# **System Pillar / EULYNX**

## **Baseline Set 4 Release 2**

Version: 3  
Date: 29-07-2024

# Error corrections

**[EUP-516] [Req. Spec. P: Incorrect IO Flow on SD 2.1.2.4.9 \(Eu.P.5804\) and 2.1.2.4.10 \(Eu.P.5374\)](#)** Created: 10.08.2023 Updated: 10.08.2023

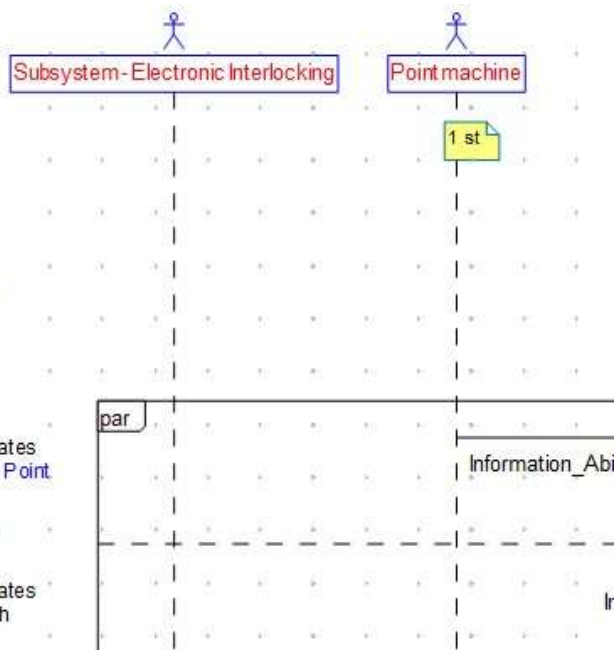
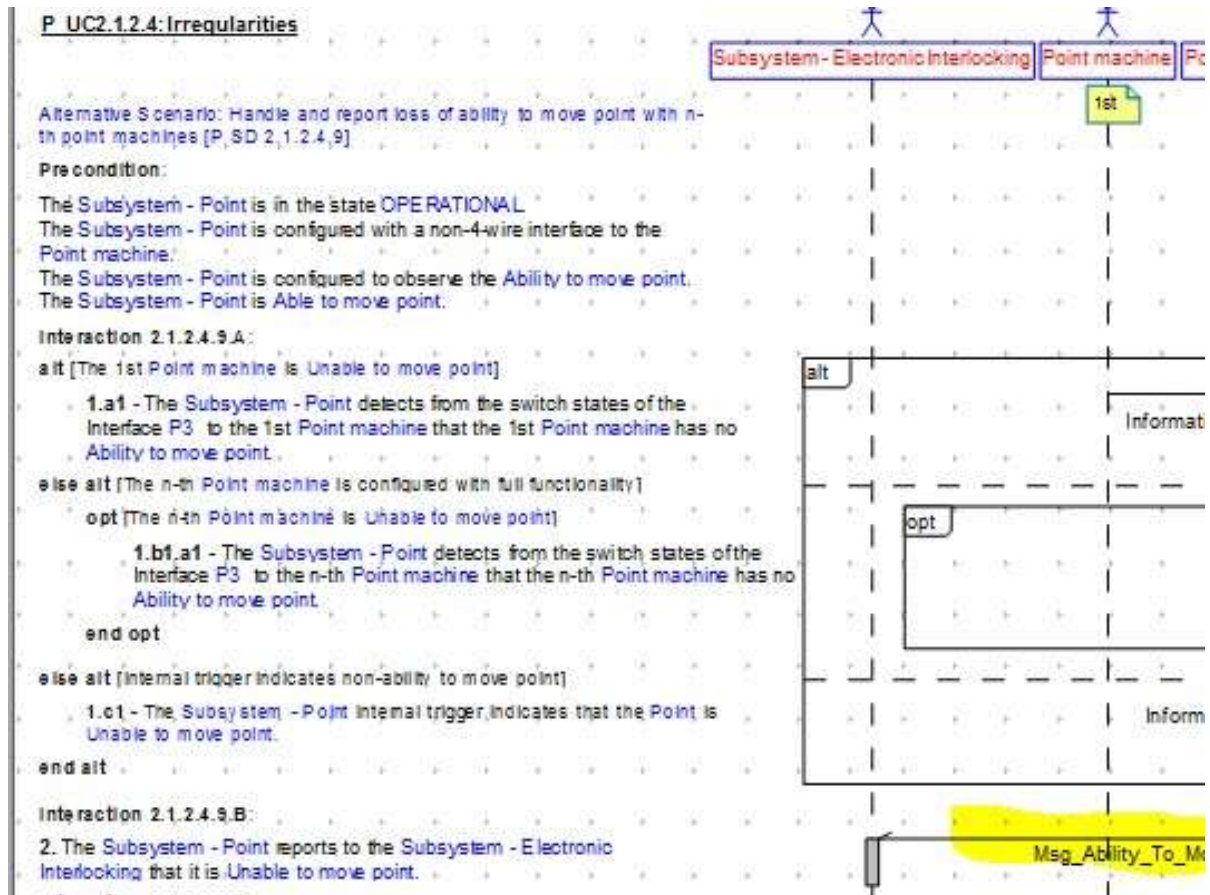
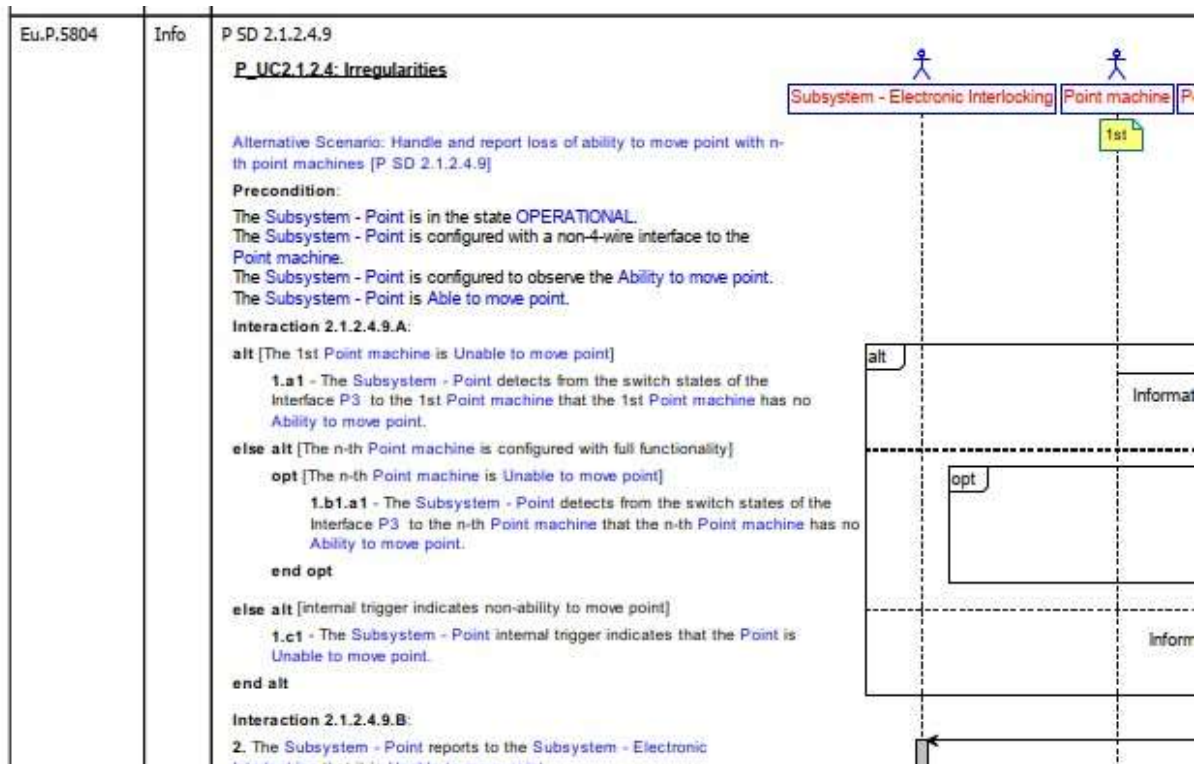
On SD 2.1.2.4.9 (Eu.P.5804) and 2.1.2.4.10 (Eu.P.5374) in on Step 2 a incorrect IO Flow is used (Msg\_Point\_Position).

Msg\_Ability\_To\_Move\_Point should be used.

Corrected in PTC. Sync, Ticketed marking needed.

image-2023-08-15-13-44-53-576.png

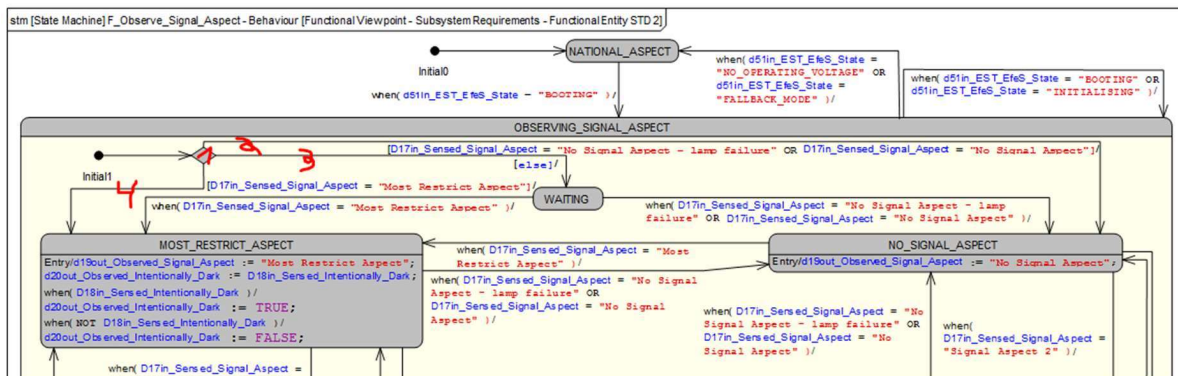
When the LS will be set from OPERATIONAL (while indicating "most restrict Aspect" back to BOOTING and then back to OPERATIONAL the controller is not able to report the newly set Aspect to the interlocking.

This is caused due to a deadlock in the observing block as it reacts just on the change trigger of D17 and can therefore not leave the state WAITING.

The STM for observe Signal Aspect shall be extended with transitions made of purely guard conditions (reacting on current state and not change trigger) as in attached pic shown. The four marked transitions/elements should be added to correct the described behaviour above.

LS 20230920: Agreed to implement in BL4R3
